Burlington Development Review Board

Development Review Board

Wednesday, November 6, 2024, 5:00 PM

1 GAS METER OPTIONS - SITE PLAN
Scale: 3/32" = 1'-0"

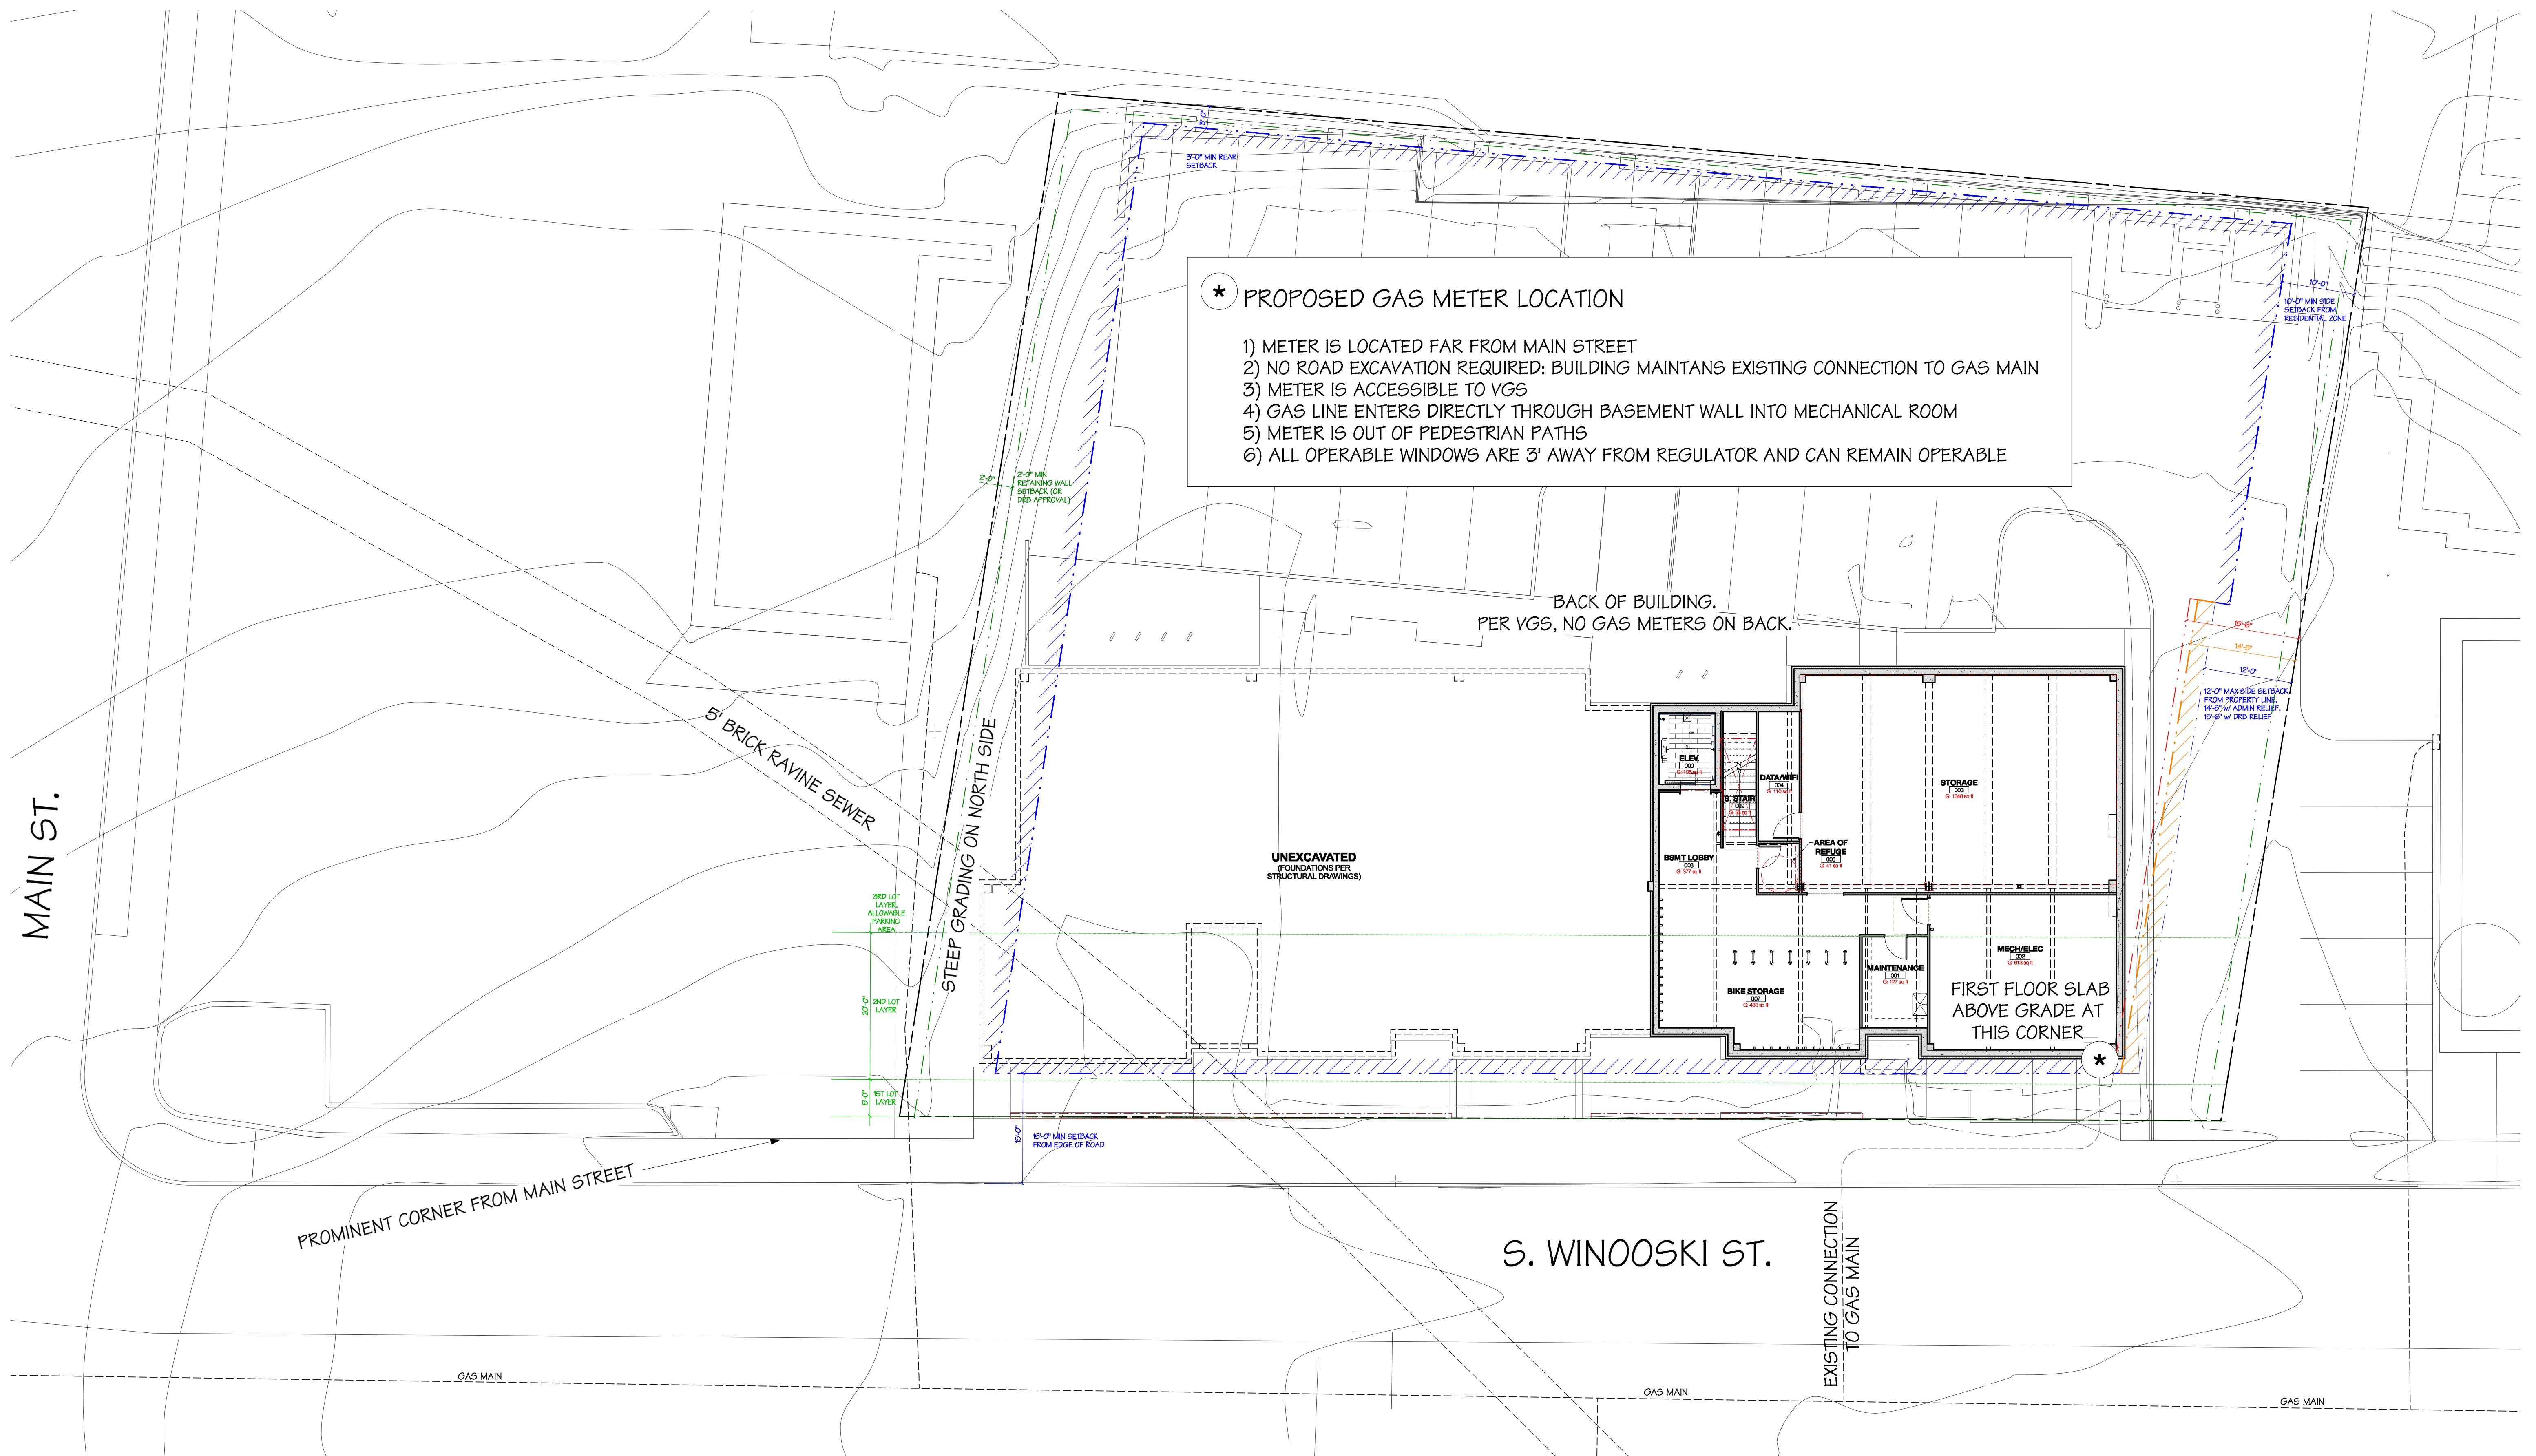
We are seeking relief for locating a gas meter on the lower front right corner of the primary facade to accommodate unique site circumstances. The owners and architect will be present at the DAB meeting to discuss and answer any questions. The following unique and challenging circumstances, rules, regulations, and existing conditions led to our proposed location of the gas meter.

It would require a longer run for the gas line under the concrete slab of the 5-story building with an occupied office commercial space above the slab. It would be difficult if not impossible access for future repair. It would also require VT Gas to dig up a recently re-paved S. Winooski Avenue to provide a new service line from their main.

East Elevation Existing Conditions

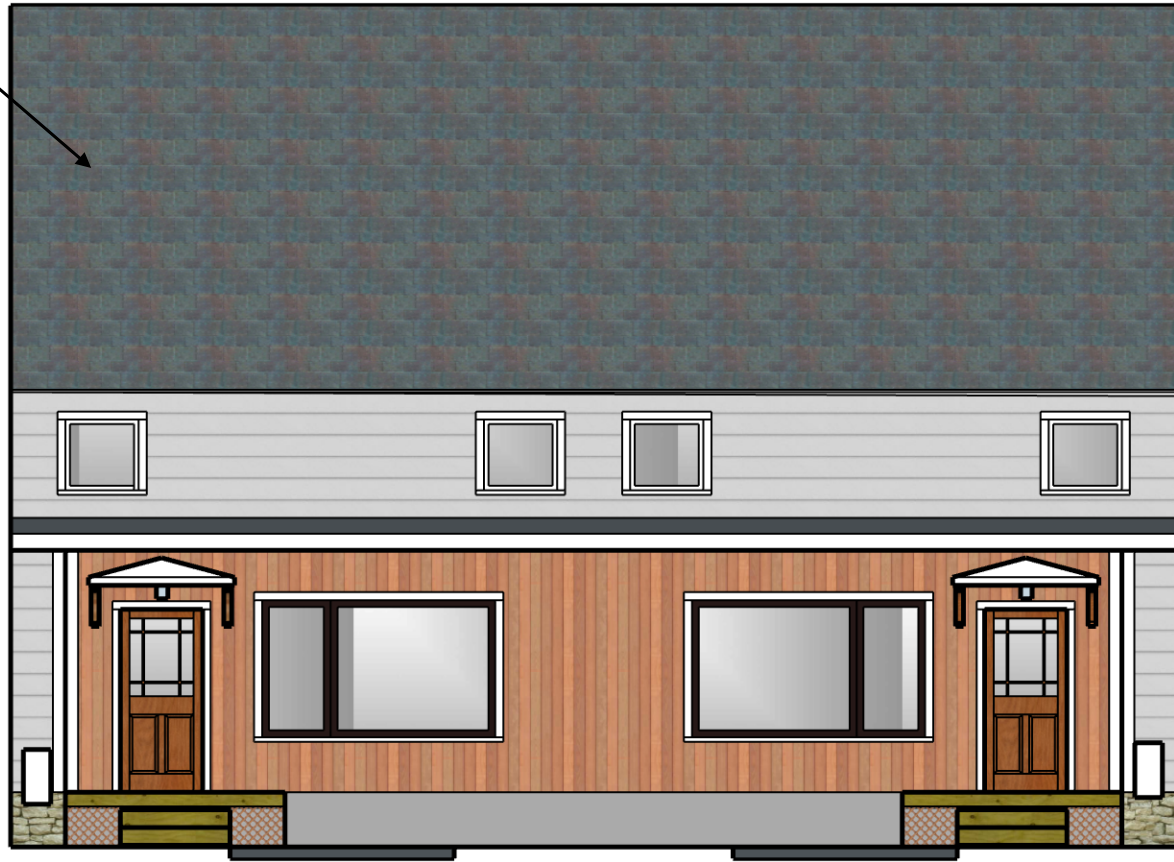
We feel the chimneys could be added at any given time in the future; they are not a long-lived feature that would need to be changed like the roof, or windows. We would ask you to consider that if faux facade chimneys are accepted, why couldn't they be added back to the house at a later time if desired.

In closing, despite chimneys being a consistent part of the historical aesthetic within this neighborhood, we feel the other visual details stand out much more and the non-functioning/irrelevant chimneys would not be visually missed. We feel the benefits of allowing them to be removed far outweigh the historical character and respectfully ask you to allow for the removal of the chimneys.

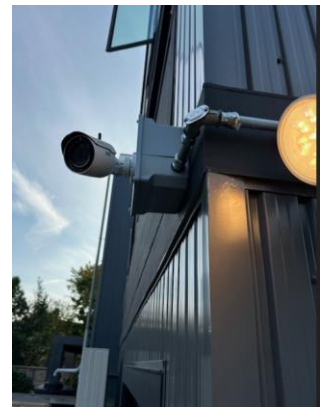
The application was originally approved with recessed lighting in the canopy above the ground floor entrances, and within the covered second-story decks. Both have largely been eliminated.

A fixture information sheet for motion activated floodlights (and photos showing their installation) were provided. The use of floodlights is prohibited unless approved by the DRB. (Section 5.5.2 (f) 7.) Those installed do not have baffles or other restraining shields to prevent glare and light trespass beyond the property. The applicant will need to show cause as to why cut-off fixtures cannot be used for the illumination needed. **Adverse finding.**

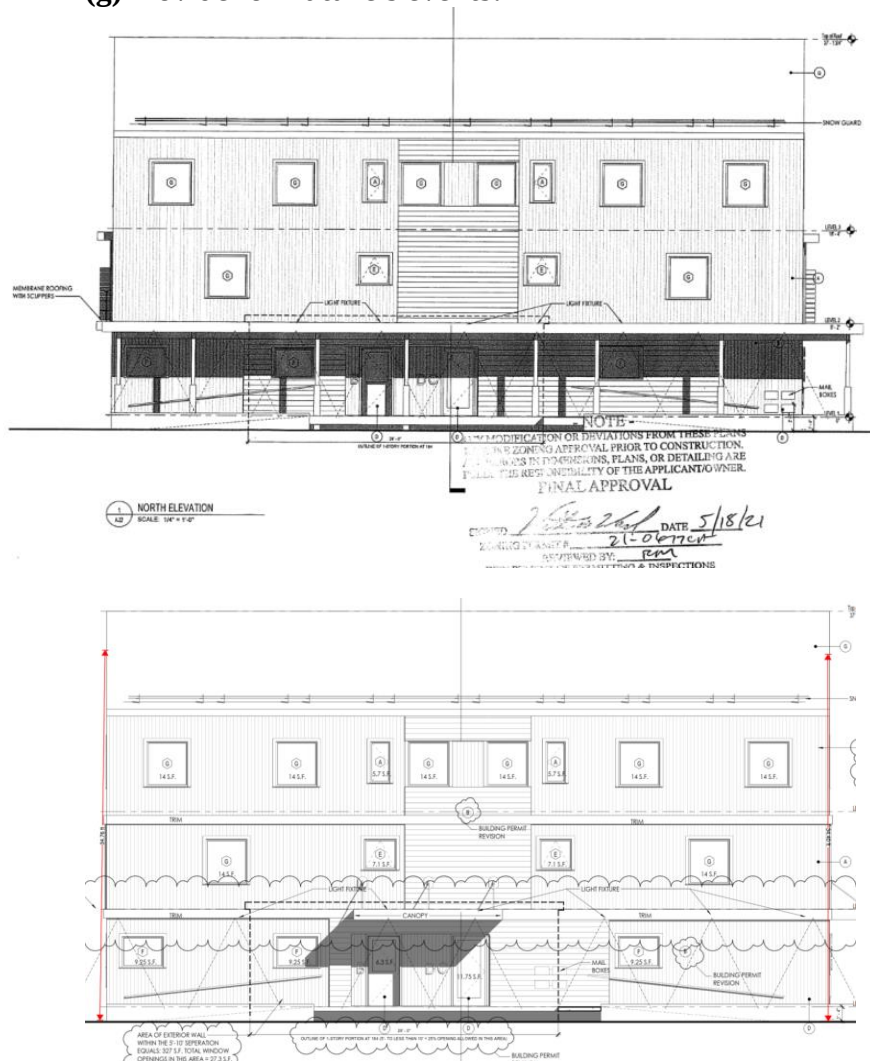
Although plans indicate the location of “Future Solar Panels”, no wind, water, solar, geothermal or other renewable energy resource was included within this application.

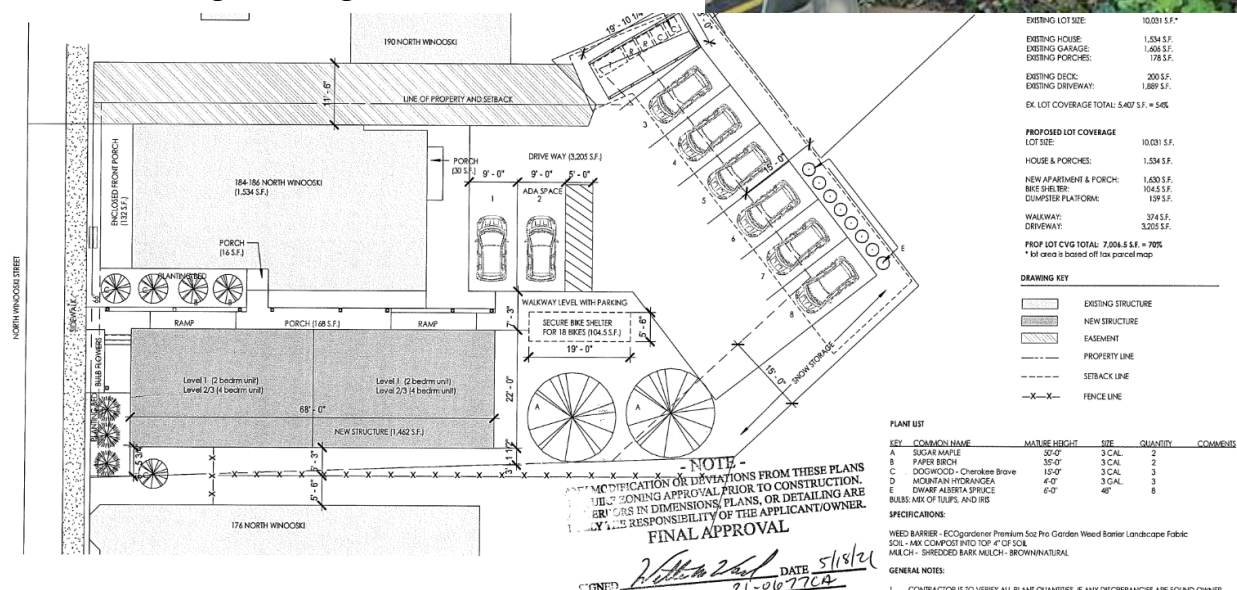
Parking is laid out as approved, but an additional vehicle is now parked where the approved site plan notes “snow storage”. This parking location, which encroaches onto green space, must be removed. **Affirmative finding as conditioned.**
